RE: EPA Request for Information & Revised Application  
Greenhouse Gas Permit Application  
Formosa Plastics Corporation, Texas  
2012 Expansion Project: Olefins Expansion  
Point Comfort, Calhoun County, Texas

The following is provided in response to the information request in EPA letter dated April 9, 2013. Each request for information is repeated below in bold italics followed by FPC TX response and supplemental information. To clarify the responses when responses are required for multiple sub-questions contained in EPA question, those sub-questions have been organized into the bullets below and responded to individually.

**REVISED GREENHOUSE GAS PERMIT APPLICATION  
PREVENTION OF SIGNIFICANT DETERIORATION:  
2012 EXPANSION PROJECT  
OLEFINS EXPANSION: OLEFINS 3 AND PROPANE  
DEHYDROGENATION PLANT  
POINT COMFORT, TEXAS**

Olefins 3 Plant BFD - 01

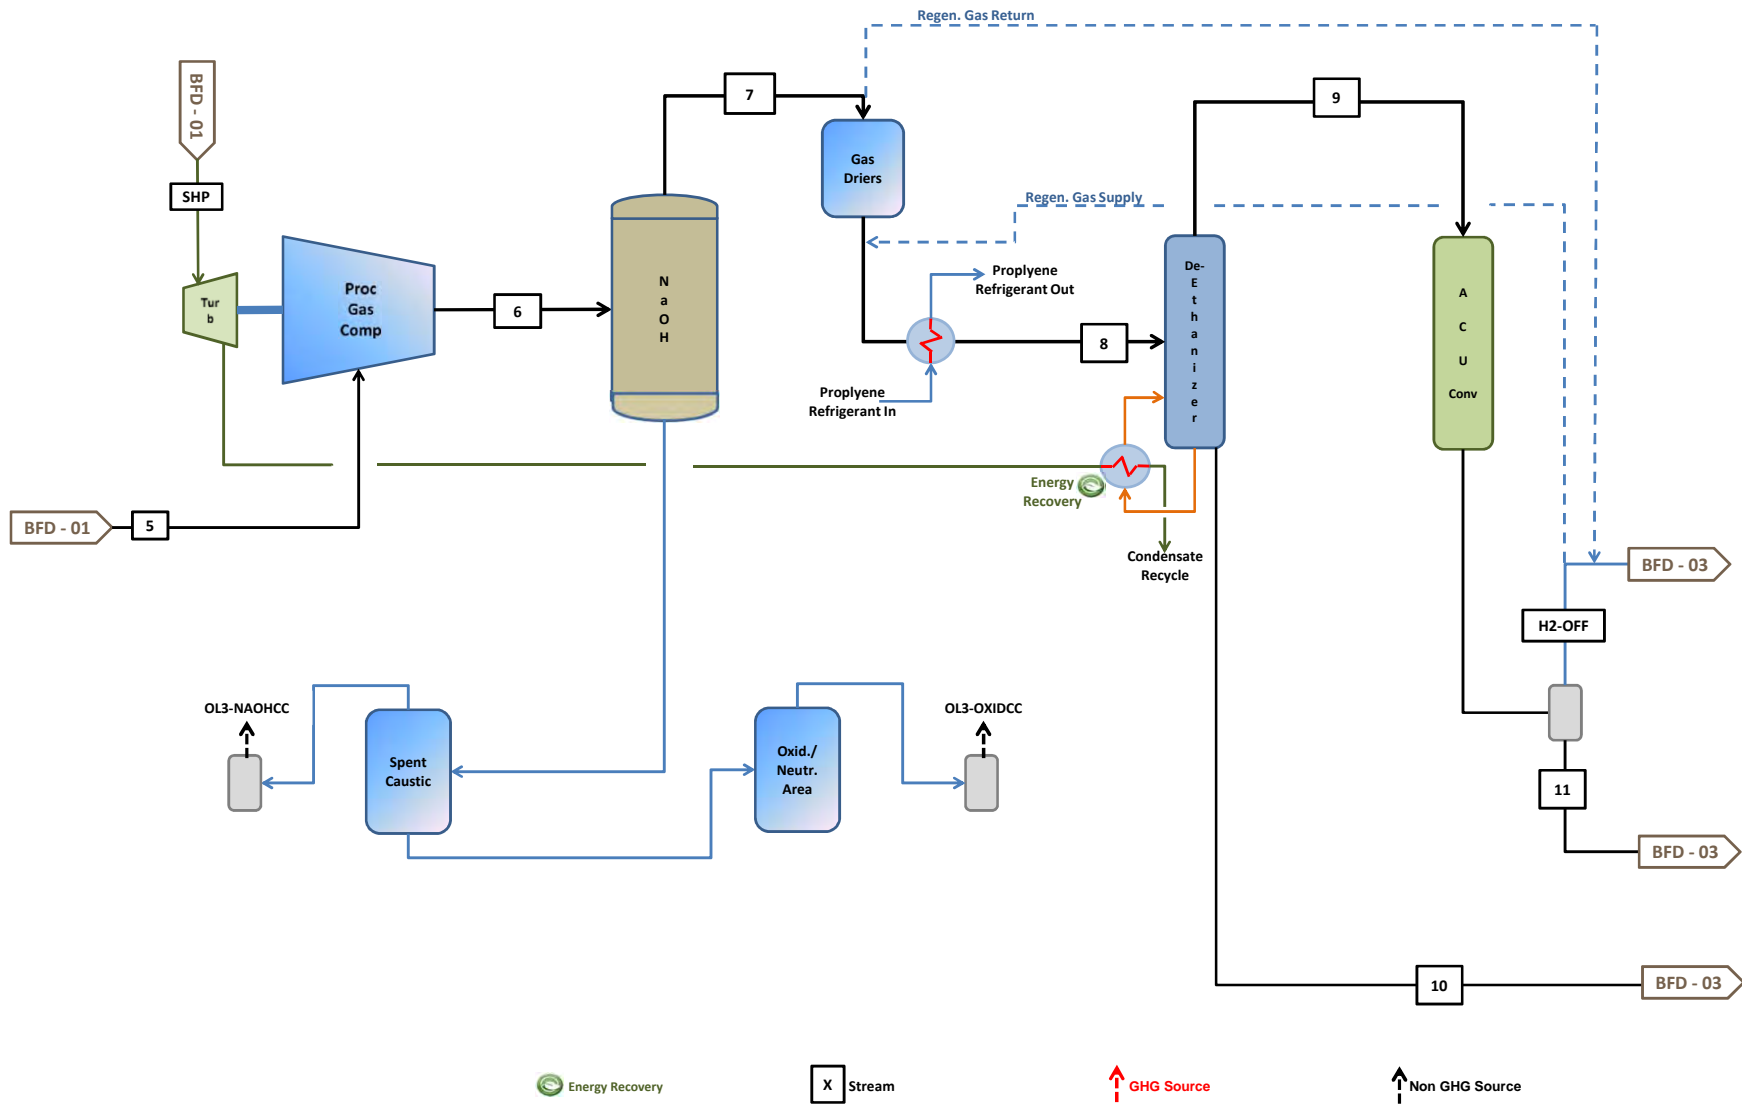
FPC TX Response: All cracking furnaces (now fourteen total) are shown on sheet BFD-01 of the revised Olefins 3 process flow diagram (see revised permit application).

FPC TX Response: The process water stripper and associated closed-loop water treatment stream are shown on sheet BFD-01 of the revised Olefins 3 process flow diagram (see revised permit application).

Olefins 3 Plant BFD - 02

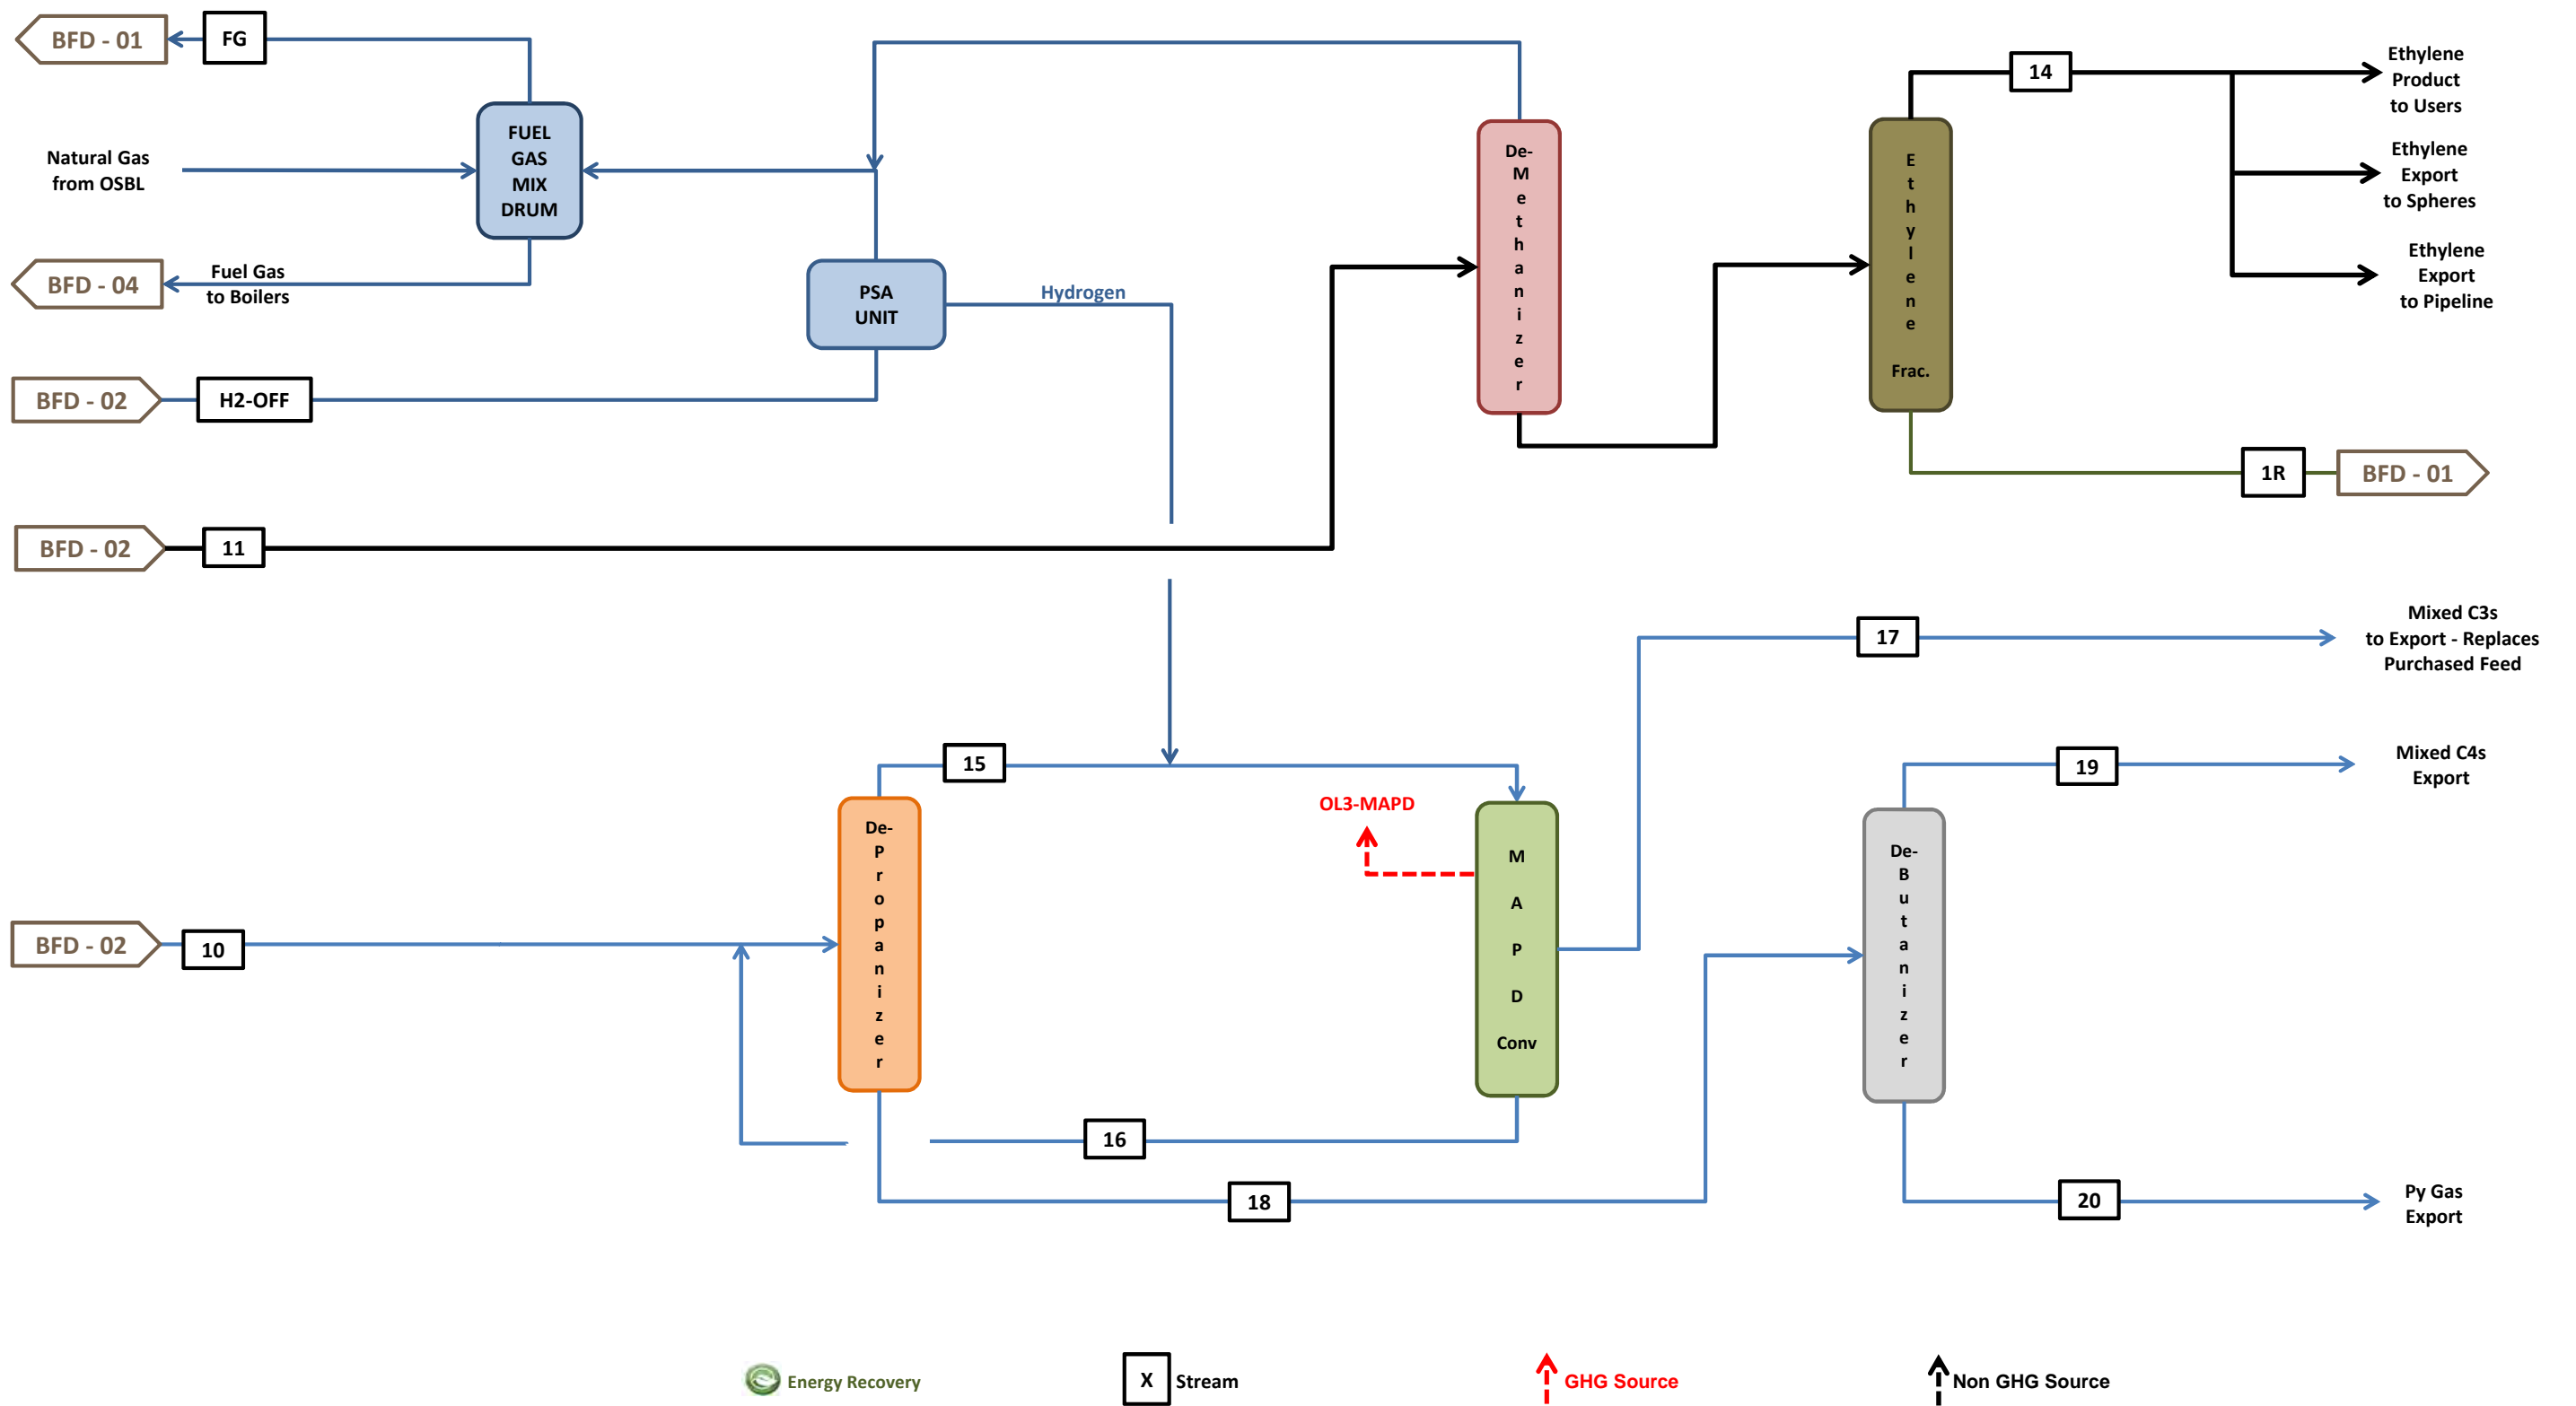
FPC TX Response: These streams are now shown in more detail on sheets BFD-01 and BFD-02 of the revised Olefins 3 process flow diagram (see revised permit application).

FPC TX Response: The carbon canisters are not GHG emission sources and have been added to the process flow diagram on sheet BFD-02 (see revised permit application). Non-GHGs pollutants (hydrocarbons) from the carbon canisters are being authorized in the TCEQ permit application.

Olefins 3 Plant BFD - 03

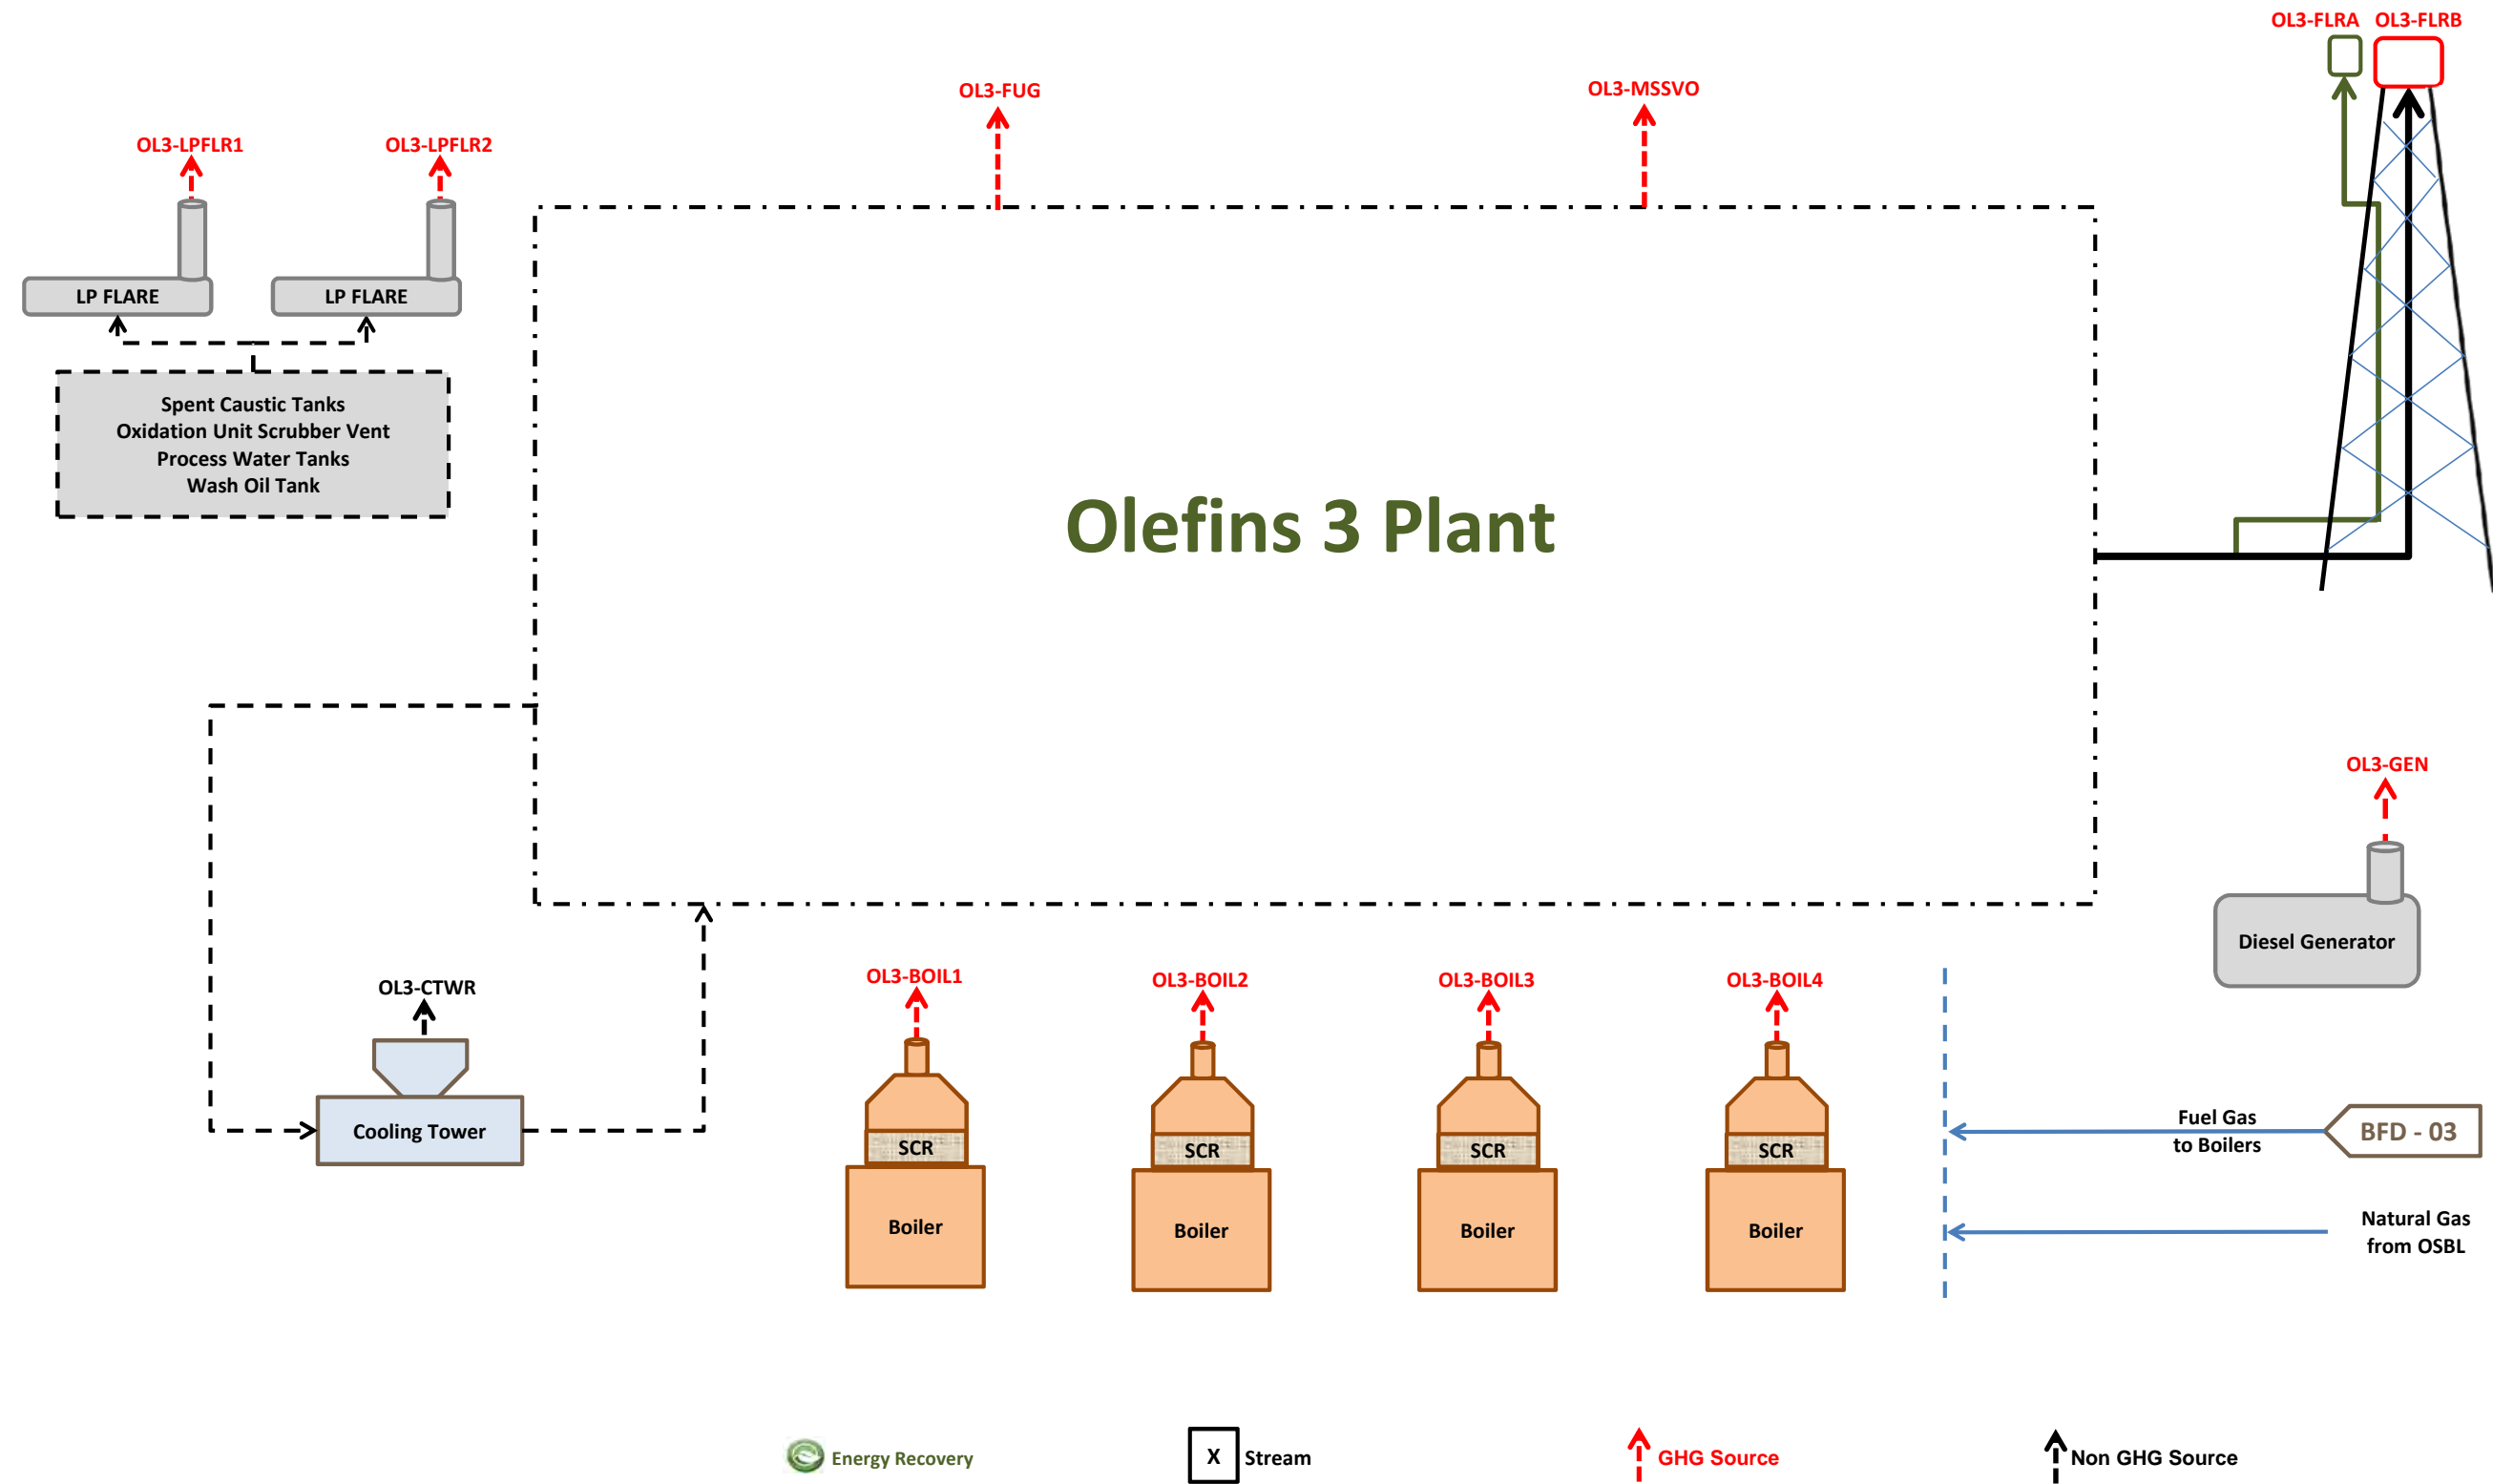
FPC TX Response: The PSA is not an emission source (GHG or non-GHGs). Any process gases from this unit are recycled to the fuel gas system. The PSA has been added to sheet BFD-03 of the revised Olefins 3 process flow diagram (see revised permit application).

FPC TX Response: The fuel gas mixing drum is not an emission source of GHGs or non-GHGs. The fugitive piping components associated with the mixing drum are GHG and non-GHG emission sources which have been identified and accounted for in the

permit application. The fuel gas mixing drum has been added to sheet BFD-03 of the revised Olefins 3 PFD (see revised permit application).

### DETAIL OL3 HEATER (Flow and Energy Recovery)

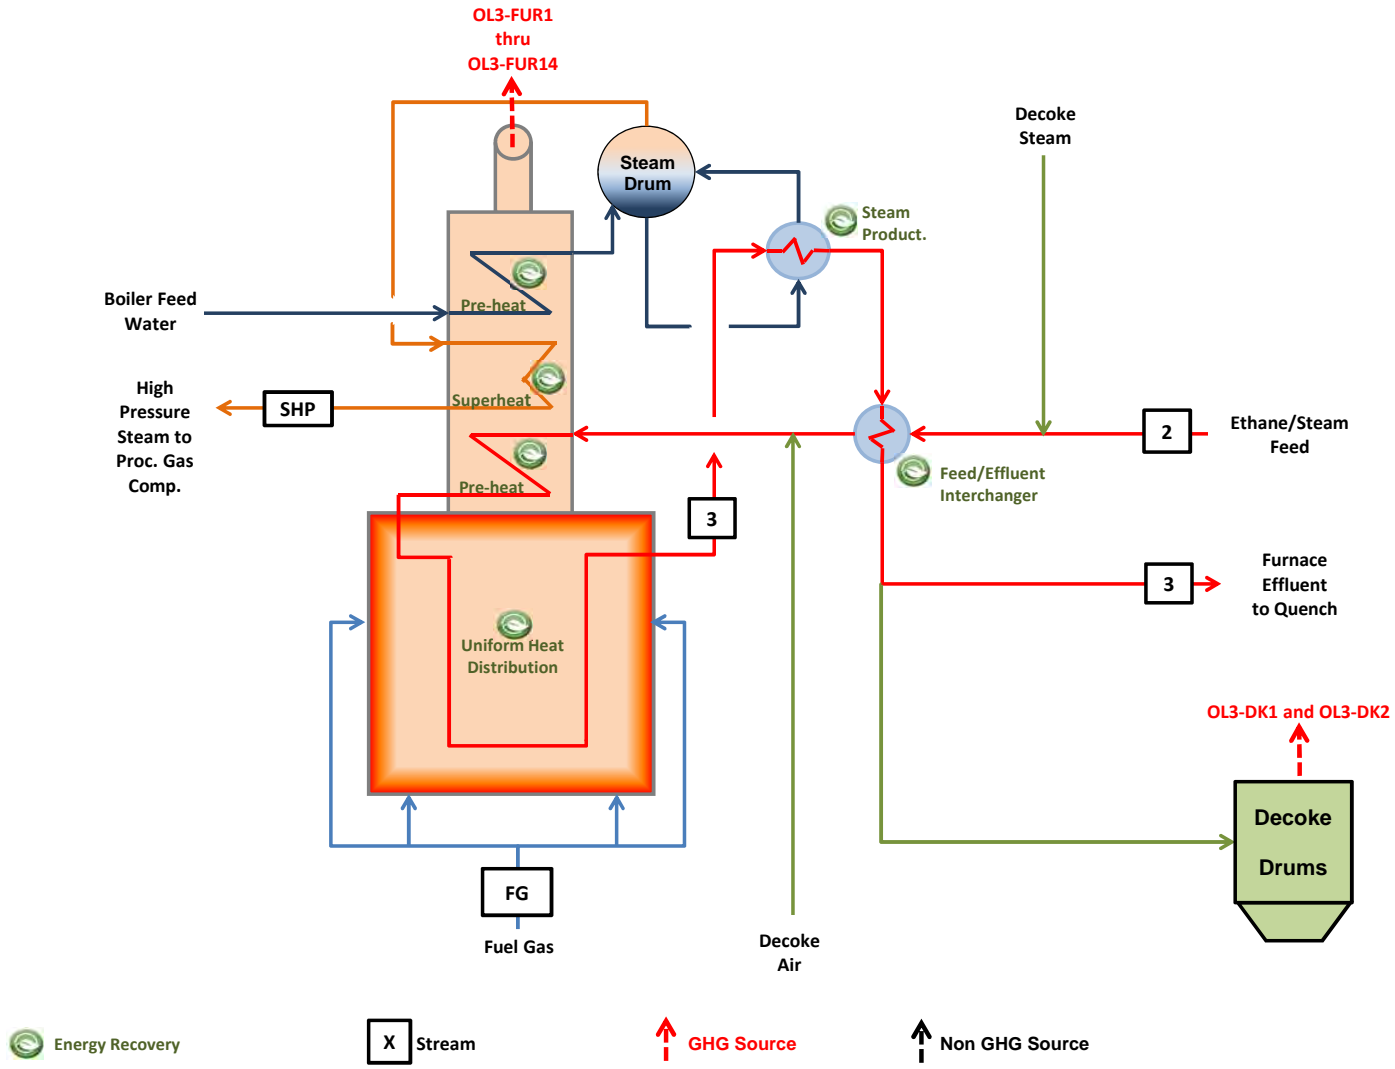
- G. Please provide a process flow diagram of the decoking system along with the emission point identification number for the GHG source. The process diagram of the system can be depicted separately to avoid overcrowding.**

FPC TX Response: The decoking system details are shown on the OL3 Heater Detail sheet of the revised process flow diagram (see revised permit application).
